Subject: Dresden Station Units 2 and 3
Quad Cities Station Units 1 and 2
NUREG 0737 Items II.F.1.4, 5 and 6
Containment Pressure, Water Level and
Hydrogen Monitoring
NRC Docket Nos: 50-237/249 and 50-254/265

Reference (a): D. M. Crutchfield letter to L. O. DelGeorge
dated November 9, 1982

ATTACHMENT
COMMONWEALTH EDISON COMPANY

Response to NRC Request
For Additional Information concerning
NUREG 0737 Items:

FIG 1

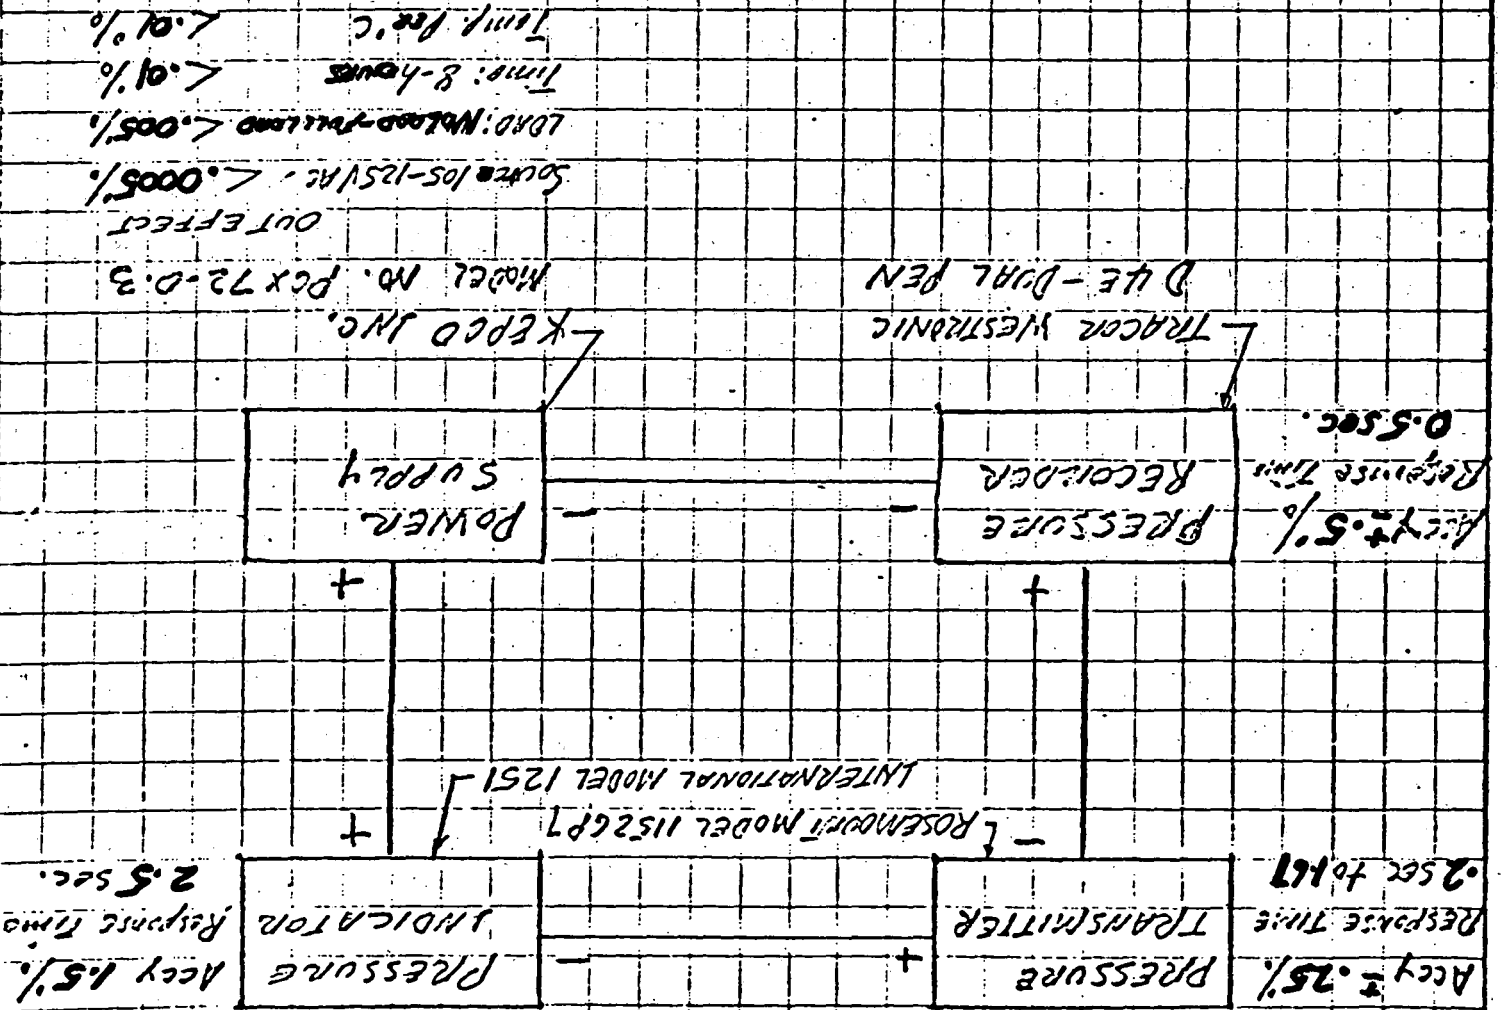
2. II.F.1.4 Pressure Monitoring System - Accuracy and Time Response

- (2a) See the attached block diagram Fig. 1.
- (2b) The following is a list of parameters which affect the accuracy of each module:
- a. Stability \pm 0.25%
 - b. Total temperature effect \pm 1.1%
 - c. Seismic performance \pm 0.25%
 - d. Radiation performance \pm 0.70%
 - e. Power supply effect \pm 0.005%
 - f. Calibration error \pm 0.5%

The temperature and radiation effects are based on the specific location of the transmitter. The environmental figures used in our calculations are based upon a Bechtel report dated April, 1980 (CECO Response to IE Bulletin 79-01, Vol. 1, Dresden - Unit 3).

- (2c) By combining the uncertainties within each module and then combining the uncertainties of each module within a loop by the square root of the sum of the squares method, the following overall loop uncertainties were derived:
- a. Transmitter to indicator: 7.06% error
 - b. Transmitter to recorder: 5.51% error
- (2d) The following is the time response for each component:
- a. Instrument tubing 0.1 sec. (estimate)
 - b. Transmitter 0.2 sec. to 1.67 sec. adjustable (time constant)
 - c. Indicator 2.5 sec. (maximum response time)
 - d. Recorder 0.5 sec. full scale (step response)

- (2e) Under the assumption that the transmitter time constant is set at its minimum value of 0.2 seconds, then the system response time to the recorder should be less than 1 second. Summing the response times of the components gives a system response time of less than 3 seconds.

Given the above, and when compared to the operator's response time, it is our judgement that the overall system time response is adequate for the intended system function and that the intent of the NUREG 0737 guidance document has been satisfied.

FIG 2

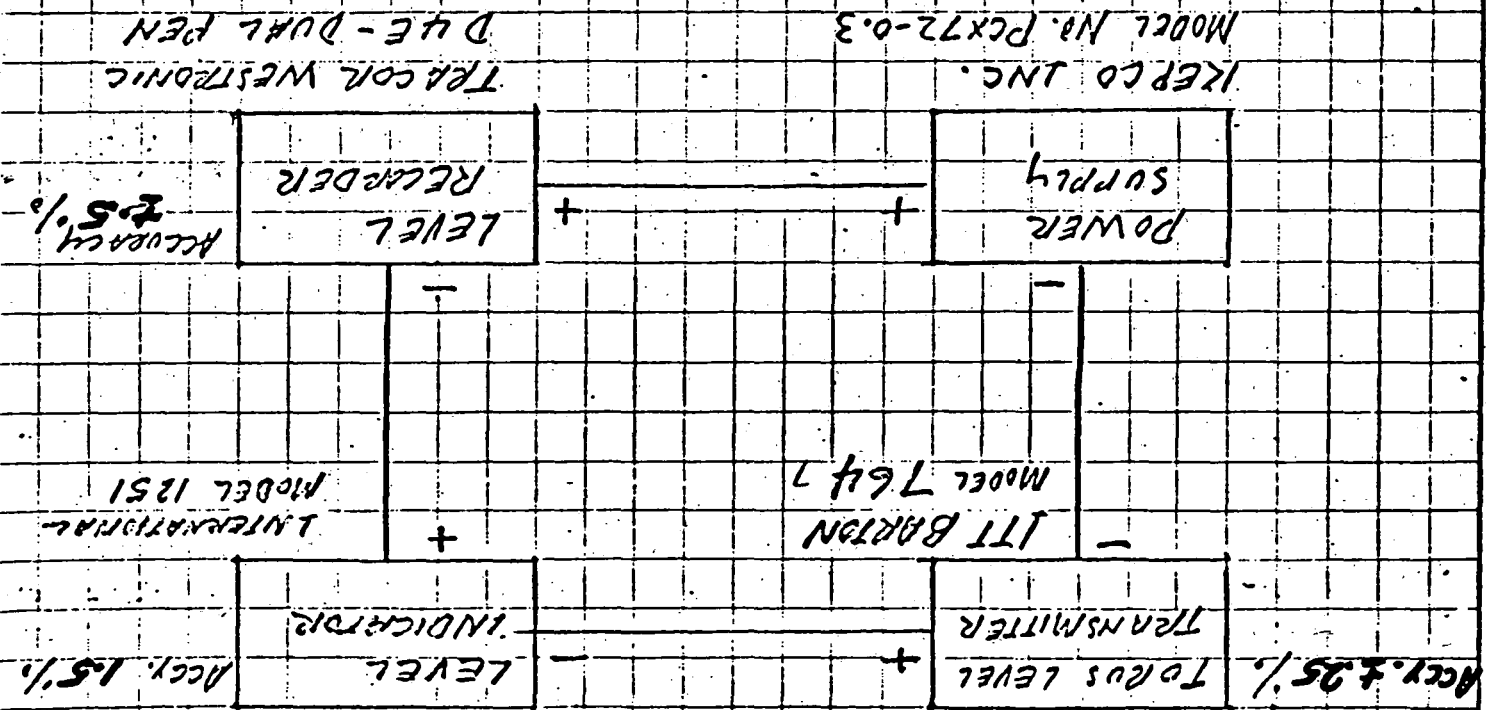
3. II.F.1.5 Water Level Monitoring System - Accuracy

(3a) See the attached block diagram Fig. 2.

(3b) The following is a list of parameters which affect the accuracy of a module:

- a. Thermal effect
- b. Radiation effect
- c. Drift effect
- d. Power supply effect
- e. Calibration error

The overall effect on a module by these parameters is estimated to be +10%. However, the effect of each parameter is not precisely known.

(3c) By combining the uncertainty of each module in a loop using square root of the sum of the squares method, the following overall loop uncertainties were derived:

- a. Transmitter to indicator: 9.4% error
- b. Transmitter to recorder: 8.3% error

DESDEN AND DUO CITIES STATIONS NUMEG 0737 FROM II.F.1.6 HYDROGEN MONITORING

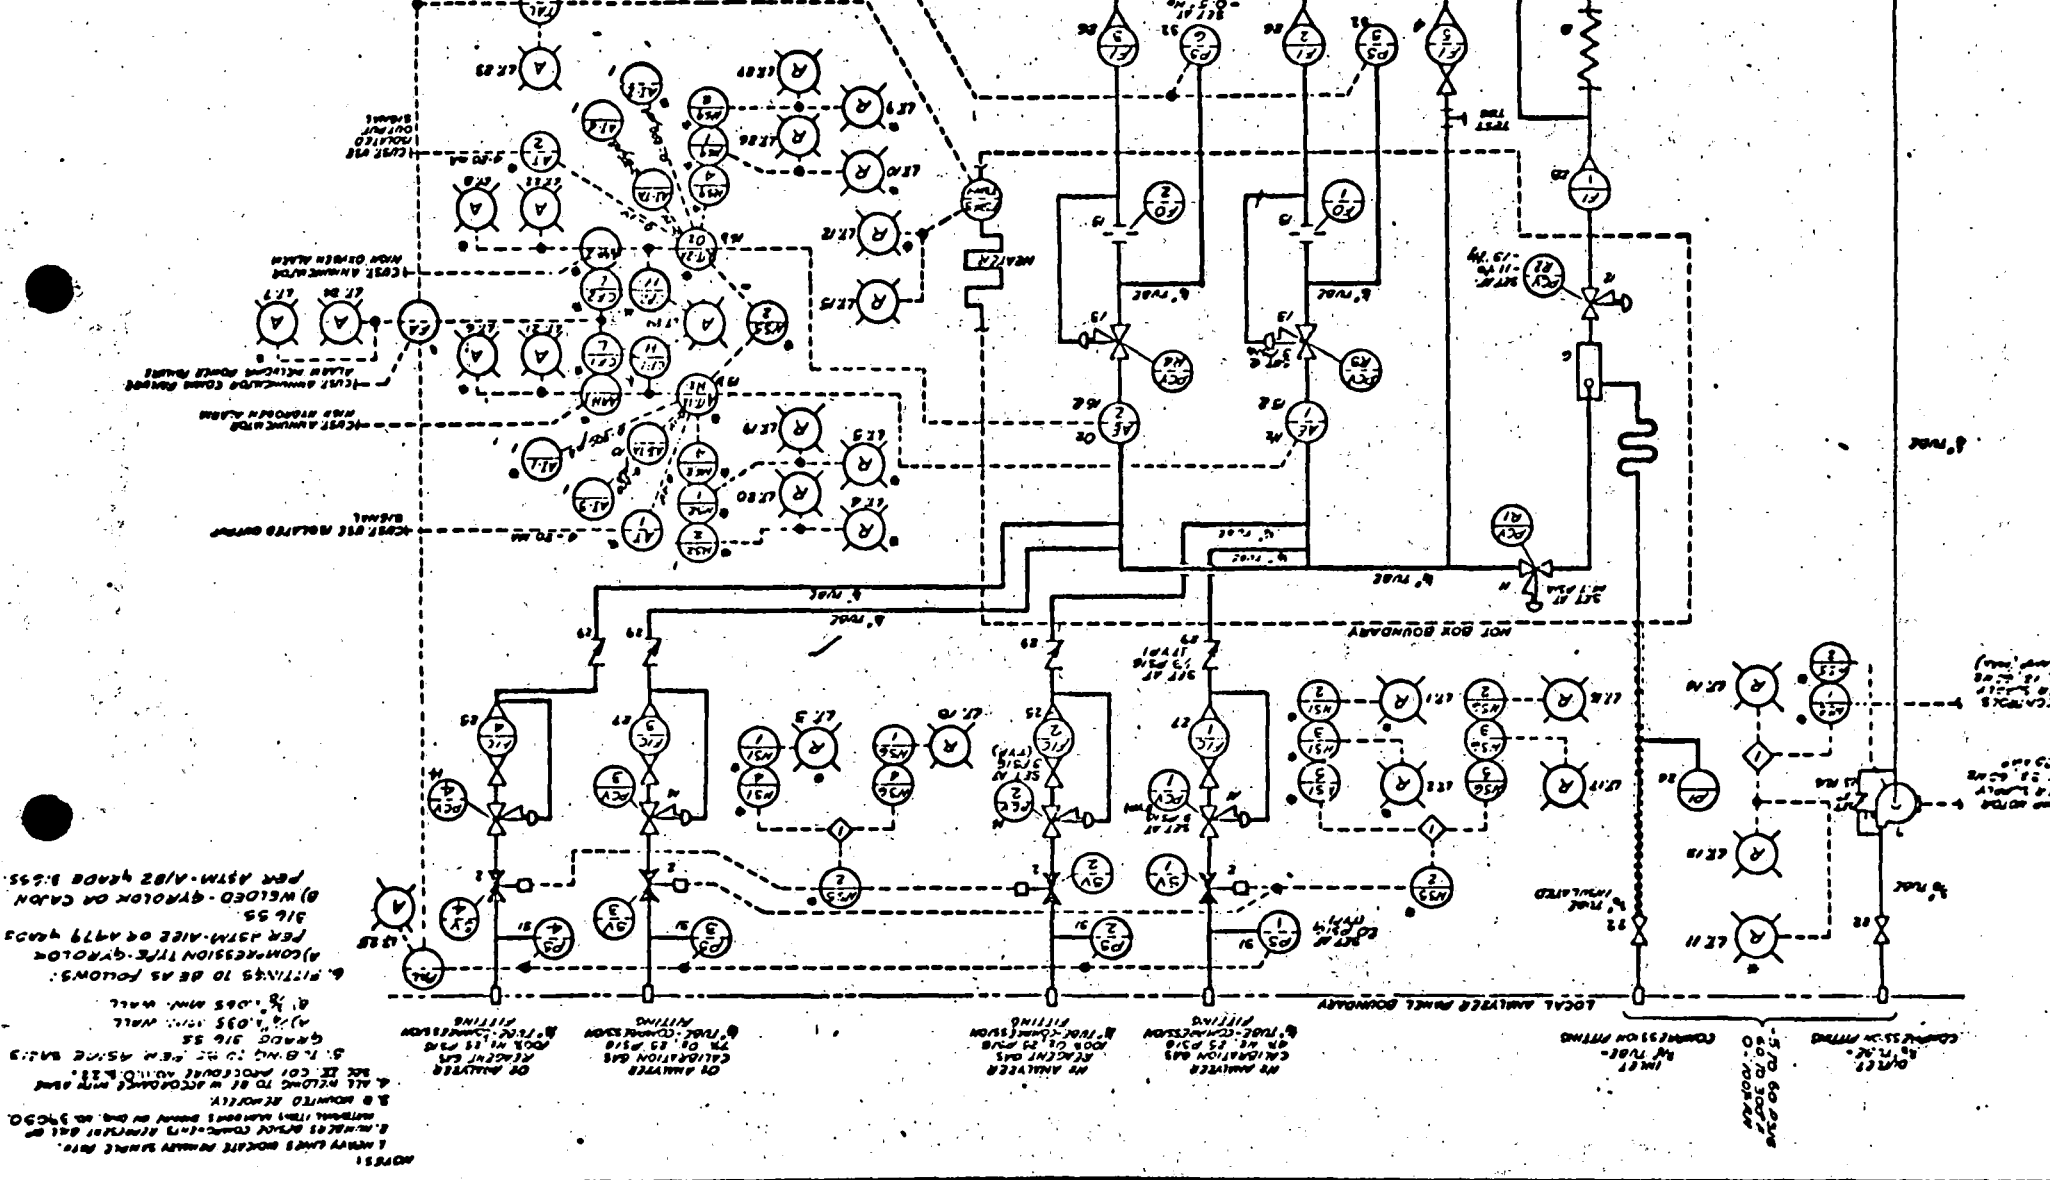
4. II.F.1.6 Hydrogen Monitoring System - Accuracy & Placement

- (4a) In lieu of a block diagram, we have included a system diagram for your information.
- (4b) The Comsip Hydrogen Monitoring System errors are as follows:
 - a. + 2% error in reading due to calibrated gas.
 - b. + 1% error in reading due to analyzer electronics (electronics located outside of harsh area).
 - c. + 1% error in reading due to flow variations.
 - d. + 1/2% error in reading due to transducer (located outside of harsh area).
 - e. + 2% error due to long term drift.

The above information was obtained from Mr. S. Lohmeyer of Comsip during telecons of November 30 and December 3, 1982. The errors are in % of full scale (10%).

Although the square root of the sums of these errors is only 3.2% error, Comsip believes that this value is low and that a conservative value of 4.5% should be used for the signal output of the system.

- (4c) Therefore, based on a 4.5% error and the accuracy of the indicator, the combined error is estimated to be 4.7%.
- (4d) There will be four hydrogen monitor intake ports on each of the two headers in each containment. The intake ports on each header will be located at four elevations approximately equidistant from each other. The headers will be on opposite sides of the reactor pressure vessel inside the containment. A globe valve on each intake port will allow throttling. The valves will be set to provide approximately equal flow into each intake port.
- (4e) There are no obstructions which would prevent hydrogen from reaching the intake ports quickly.
